# CITY OF PORTLAND, MAINE

## HISTORIC PRESERVATION BOARD

**TO:** Chair Sheridan and Members of the Historic Preservation Board  
**FROM:** Deb Andrews, Historic Preservation Program Manager  
**DATE:** January 9, 2019  
**RE:** January 16, 2019    **2<sup>nd</sup> WORKSHOP – Preliminary Review of Proposed Hotel Construction**

**Address:** One Center Street  
(northeast corner of Commercial and Center)

RENDERINGS + ELEVATION  
CENTER STREET

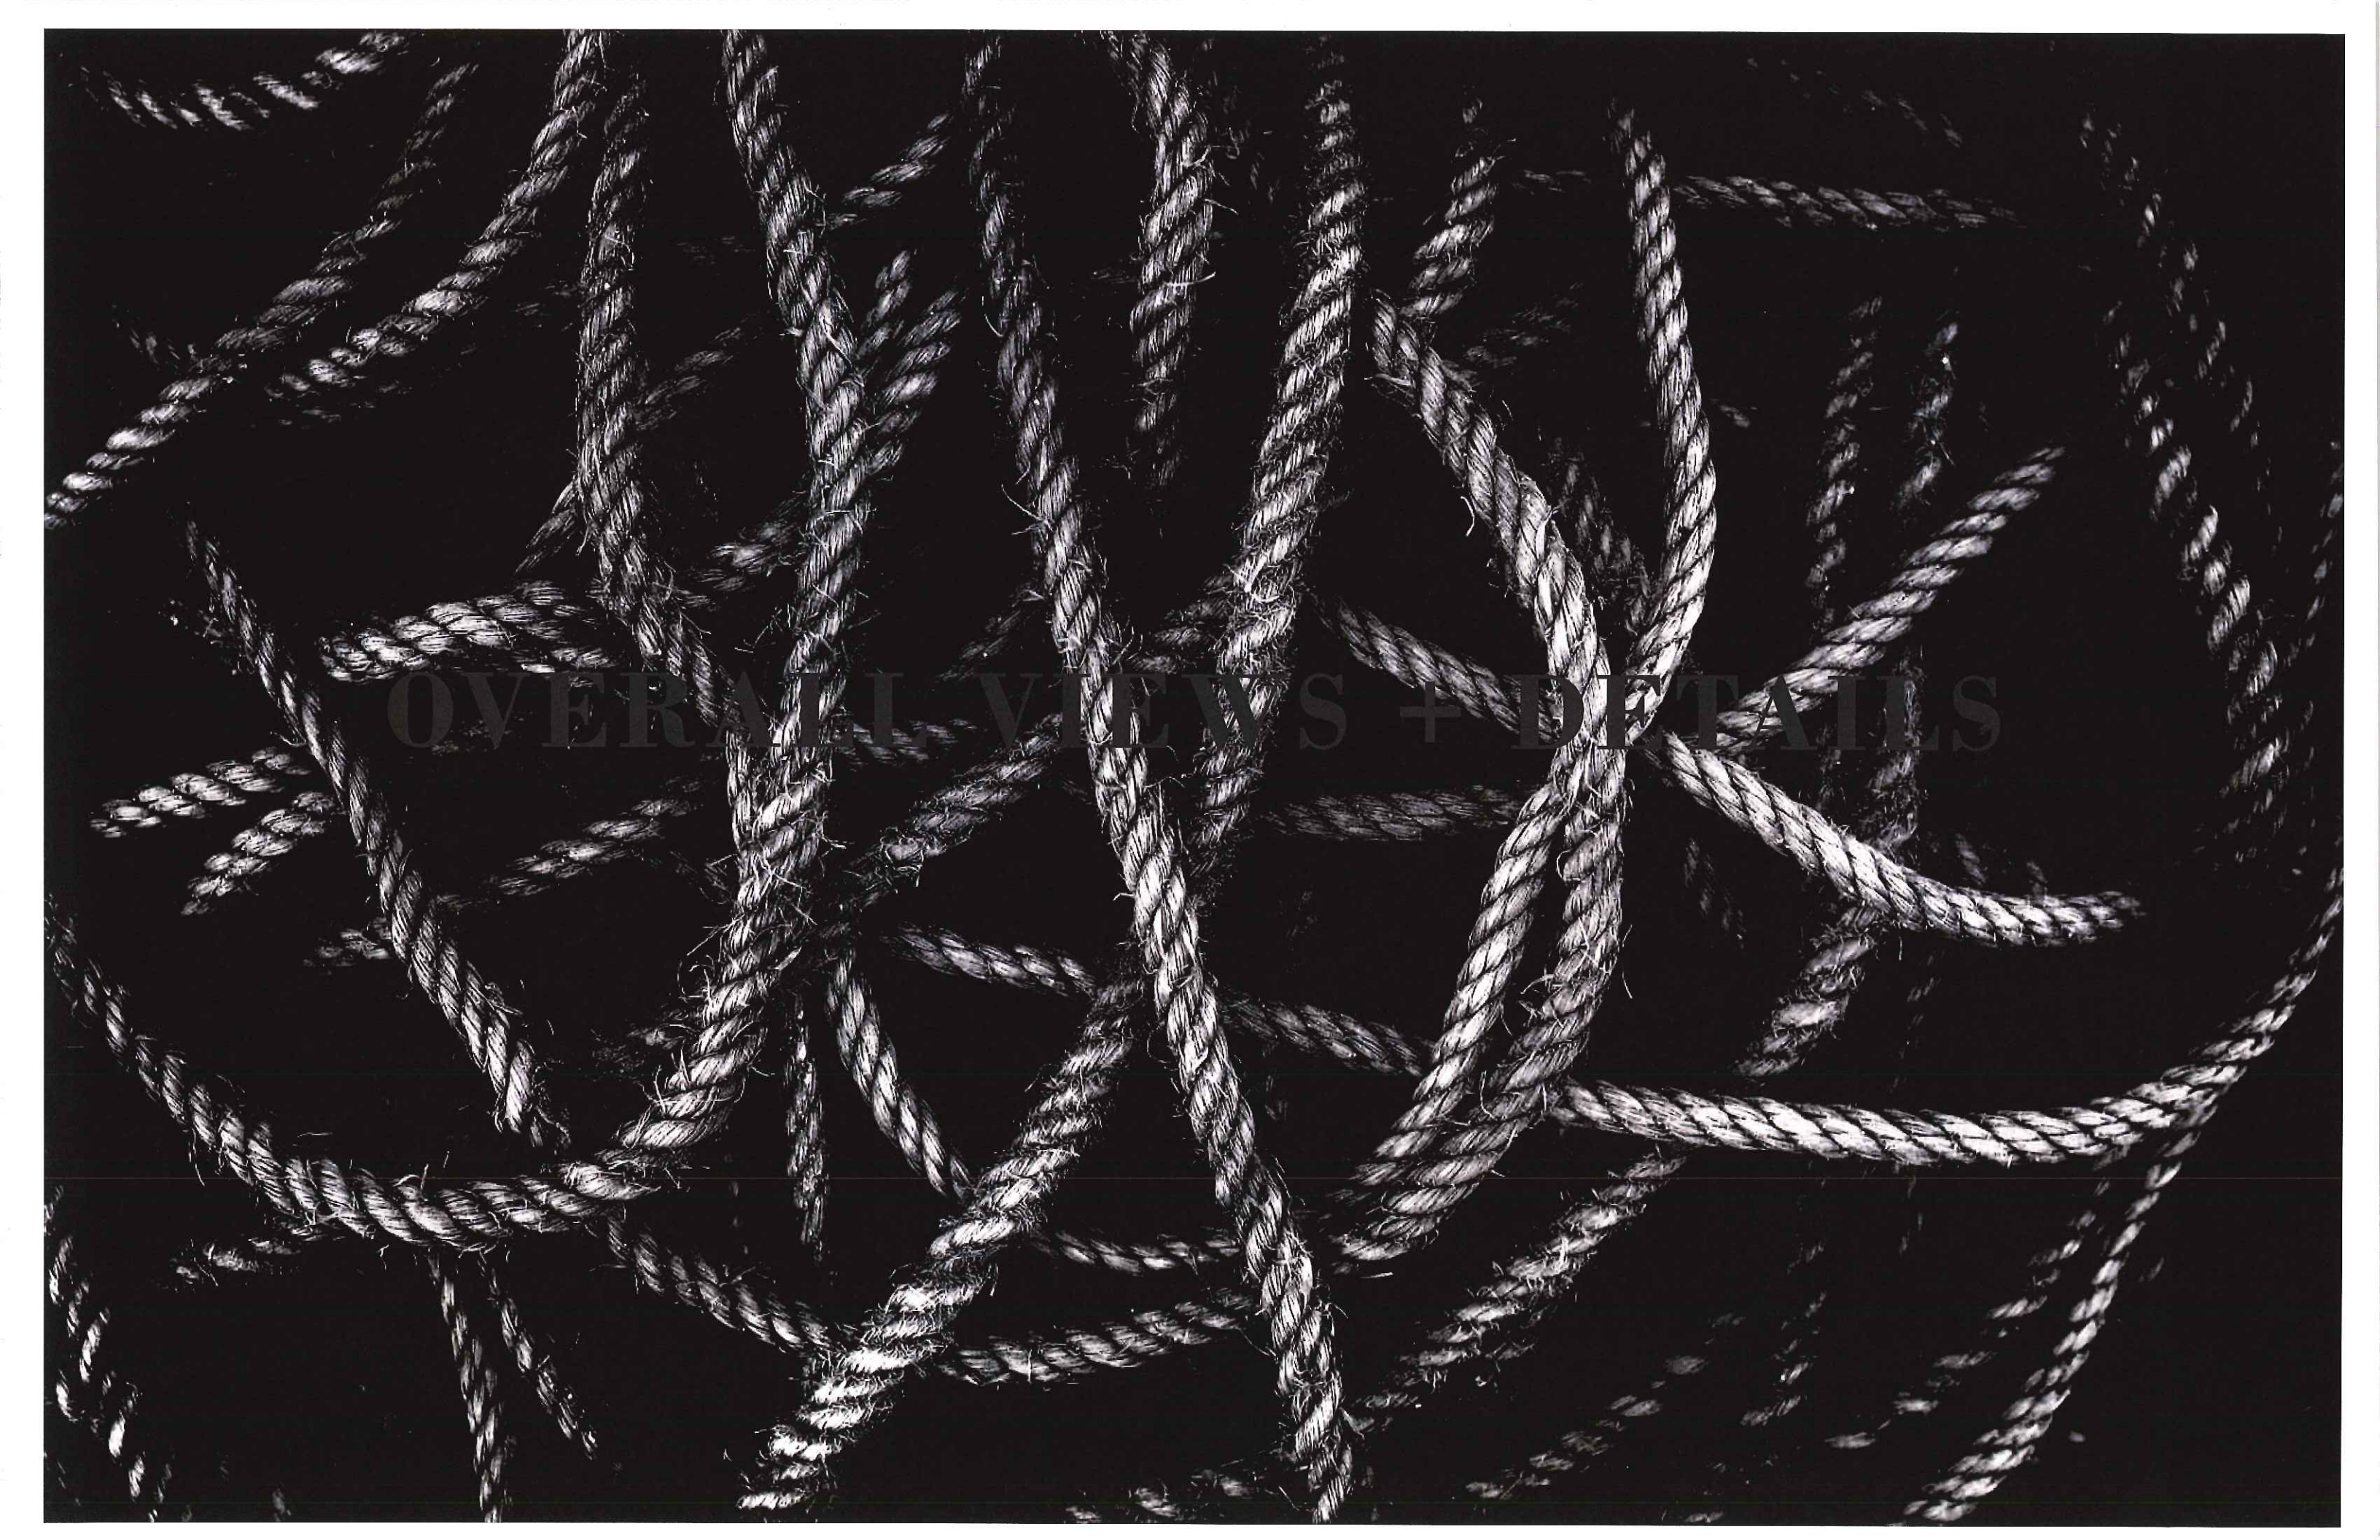
The revised proposal is responsive to the Board's feedback in a number of respects. For example, the elimination of intermediate cornices and the unification of the material palette on the upper façade has simplified and "calmed" the composition considerably. The introduction of a simple metal cornice that extends across the entire façade above the fifth-floor level also helps unify the upper façade, at least up to this level of the building. The changes to the glazed tower element at the corner of Commercial and Center are positive as well. By raising the sills and lowering the headers on the corner windows and by introducing a series of horizontal louvres, issues of privacy and visual clutter are addressed.

Staff's other concern is the applicant's proposal to add a rooftop terrace above the 6<sup>th</sup> floor on the west side of the building. Not only does the addition of the rooftop terrace further differentiate the west side of building from the east side, it also requires additional rooftop elements to accommodate it, including railings, and taller elevator overruns. Although these elements are set back from the Commercial Street elevation, given the expansive views afforded by the width and broad arc of Commercial Street, these projecting elements will be clearly visible.

However, extending this treatment across the entire top floor level could provide expanded outdoor seating for the bar and/or outdoor space and expansive views for hotel guests not patronizing the bar. With additional outdoor space at the sixth-floor level, the rooftop terrace and elevator overruns would not be necessary. Also, the overhanging canopy above the sixth floor would provide shelter for sun or inclement weather, something the proposed rooftop terrace does not provide. In staff's view, this modification in design and program would result in a more architecturally cohesive and compatible Commercial Street façade that still accommodates the desire for elevated outdoor space and expansive views.

263-265 State

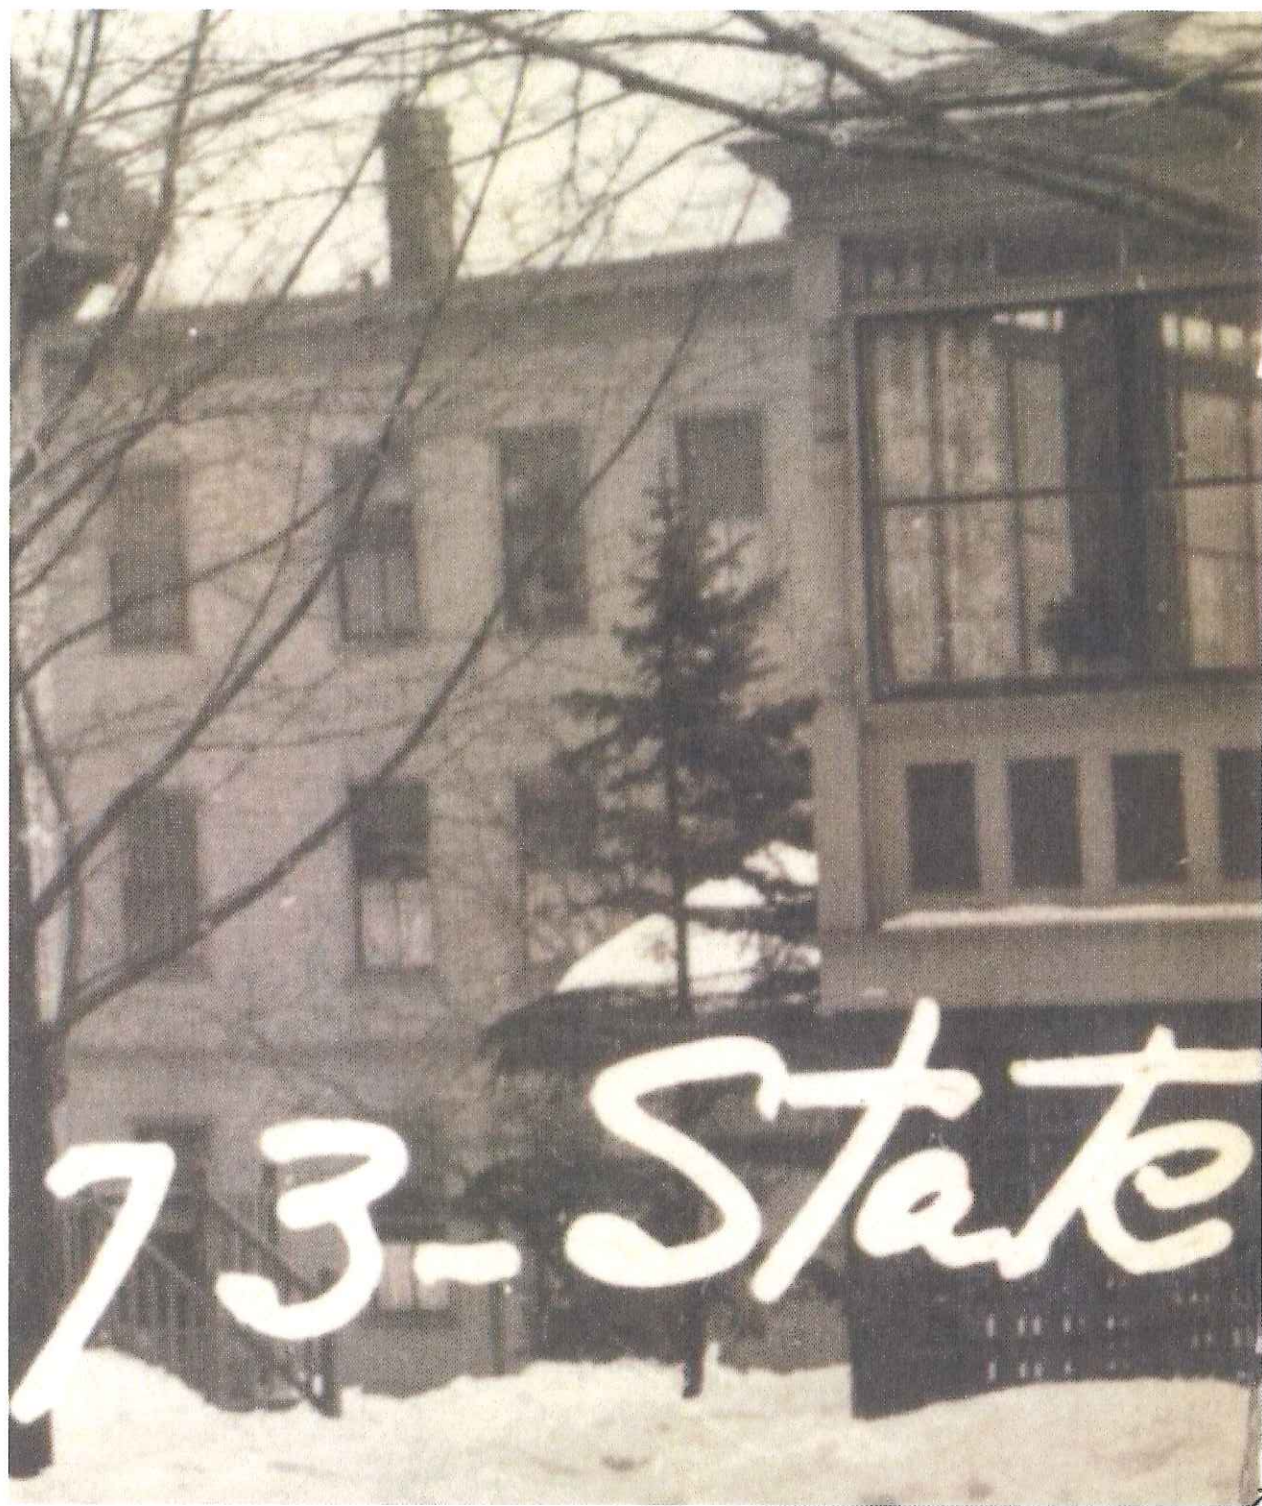
Despite some changes in the last 130 years, the character of the Stevens design is still very evident. No radical changes are proposed to the appearance, but staff believes it is important to follow a recessive and compatible direction – particularly for the skirt or base of the prominent porch on the northwest corner. Historic images (both 1924 and 1990) show a brick red square lattice show a lattice under the porch like that which exists today under the front porch, and staff recommends a return to consistency.

The glassed-in porch is a mass with a fairly solid appearance, and staff encouraged the architects to give it a reasonably solid base. With the front panel facing State Street proposed as all lattice, the question of how much to close in the north side of the base needs to be considered. Bearing in mind that the one window in the front bedroom is under the porch and has limited potential to provide a little natural light

BUILDING 12 SITE PLAN

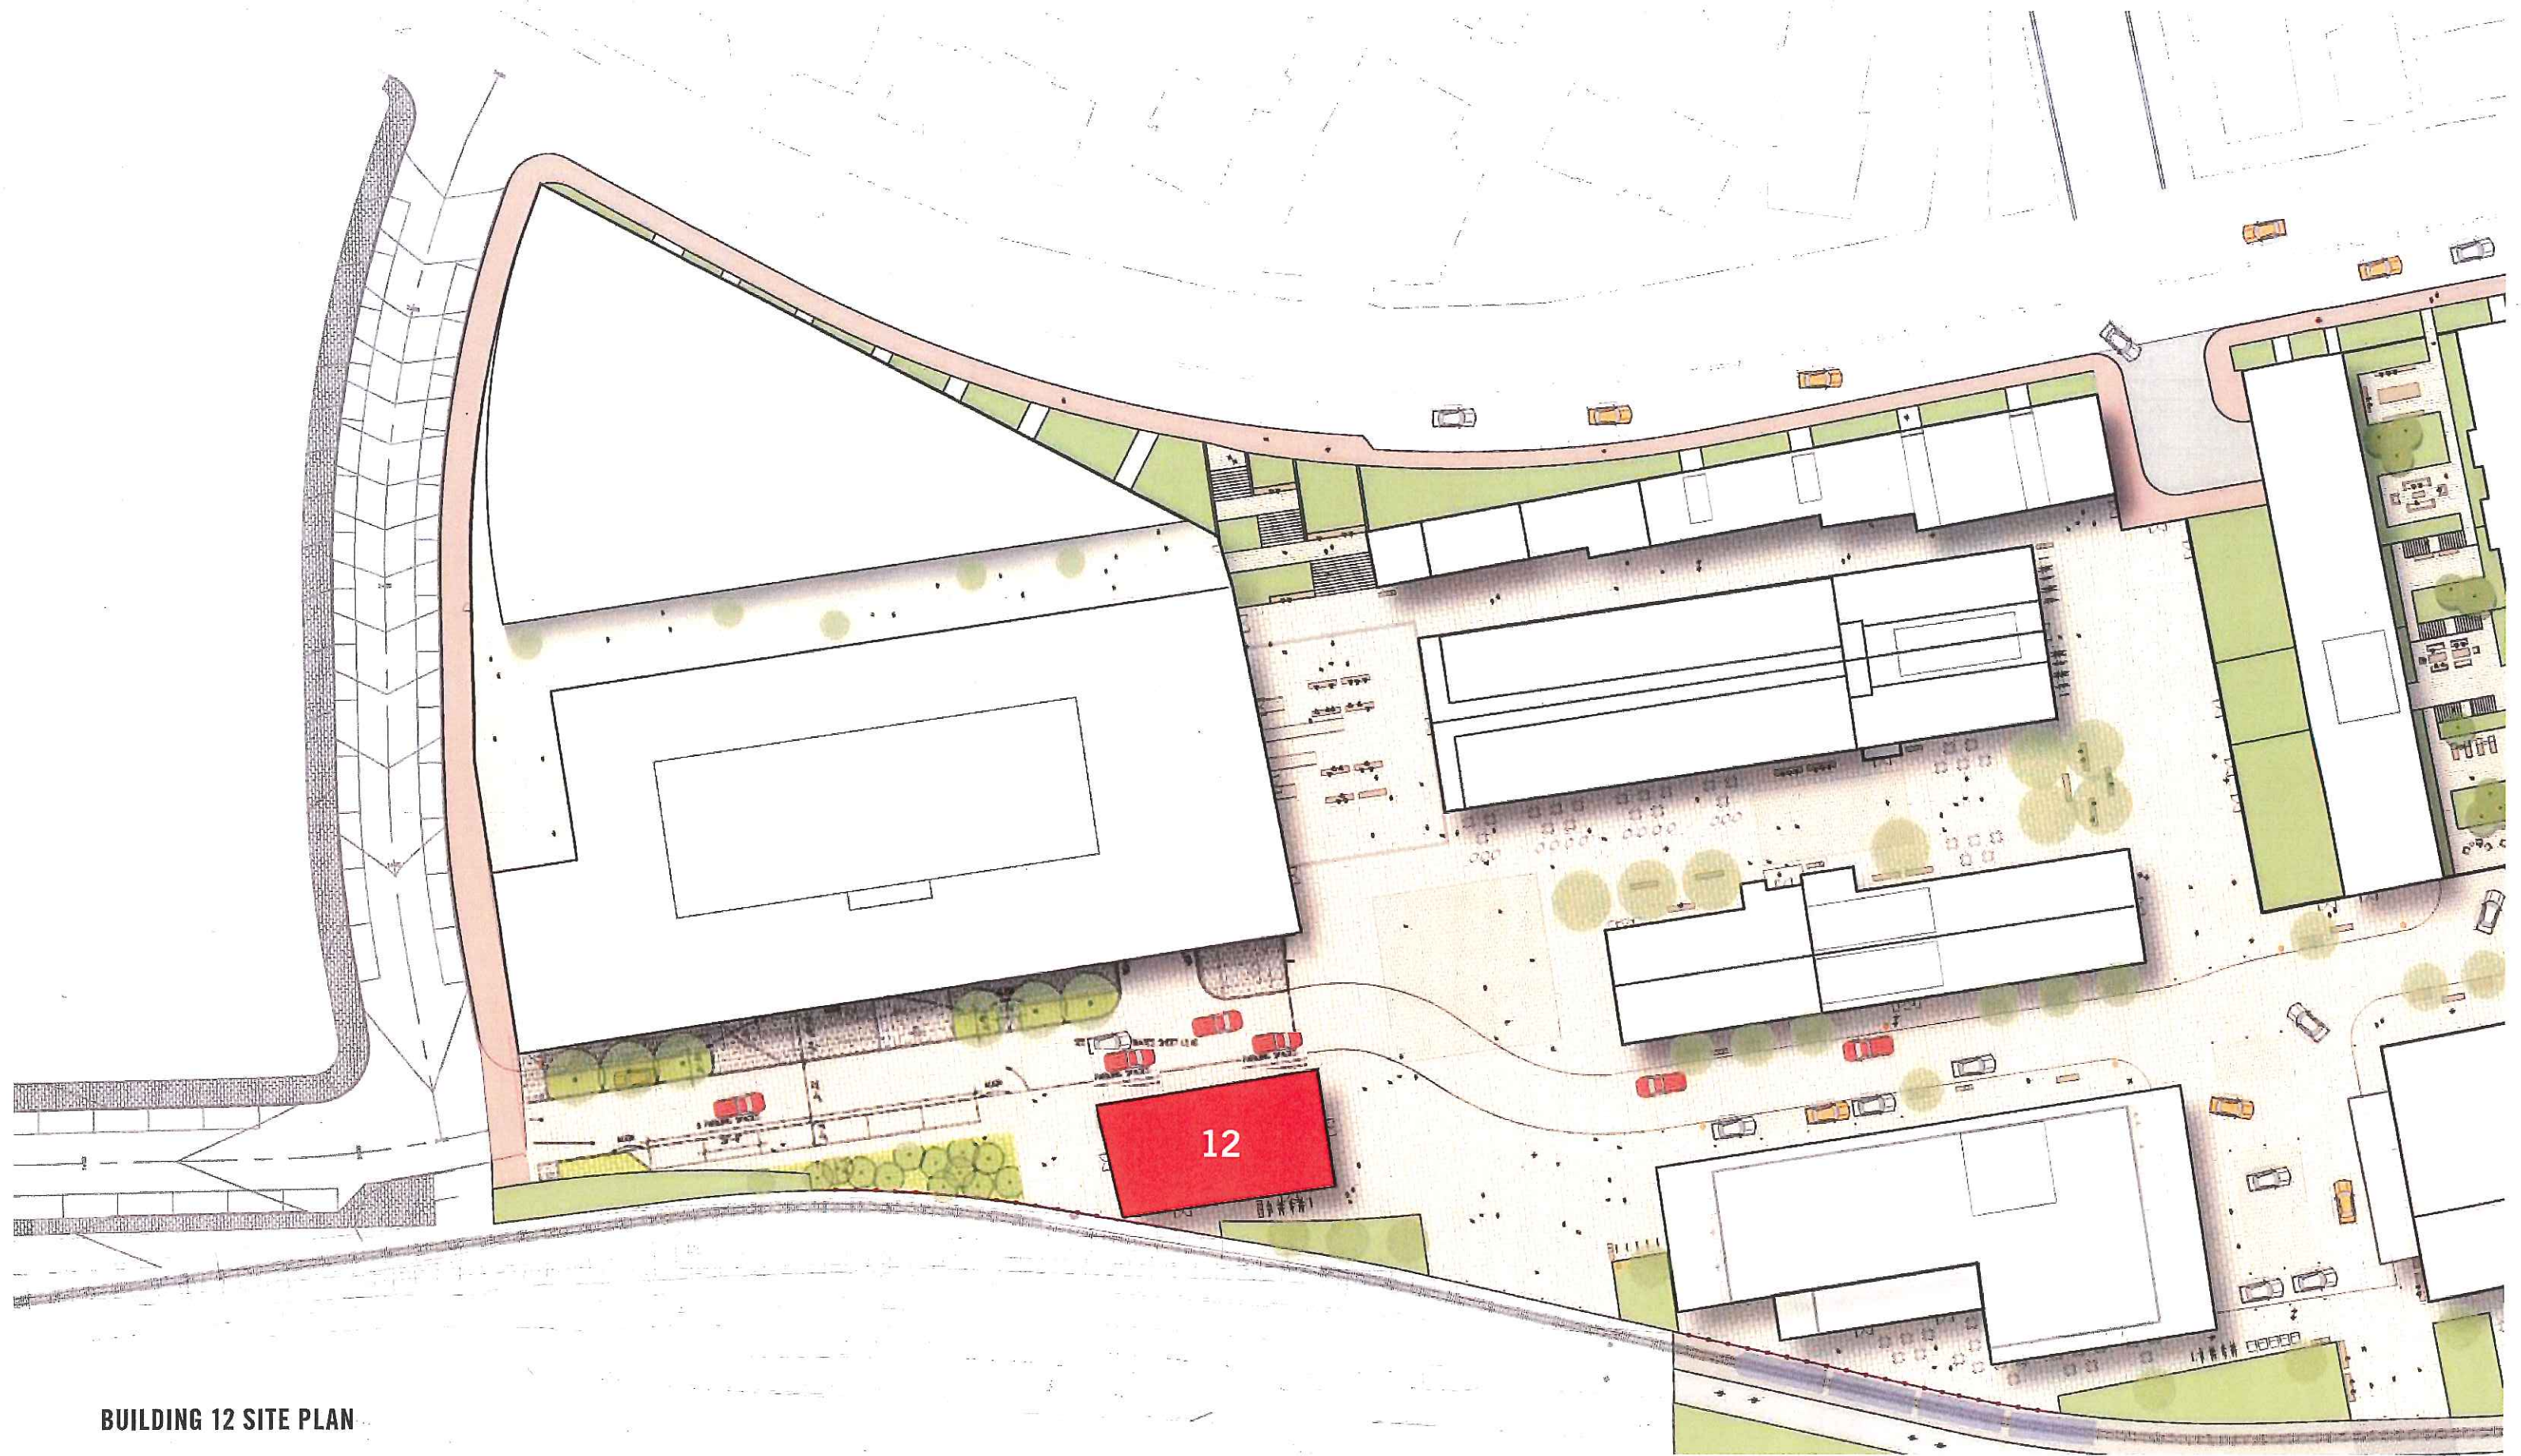
As now proposed, Building 12 would be moved to a position 50 feet south of its original proposed relocation. The building would be separated from the new office building by the access drive leading into the 58 Fore Street property. (The alignment of the access drive would be moved as well.) Project consultants Woodard & Curran outlined the arguments for this revised location in submission for the 11/18 workshop.
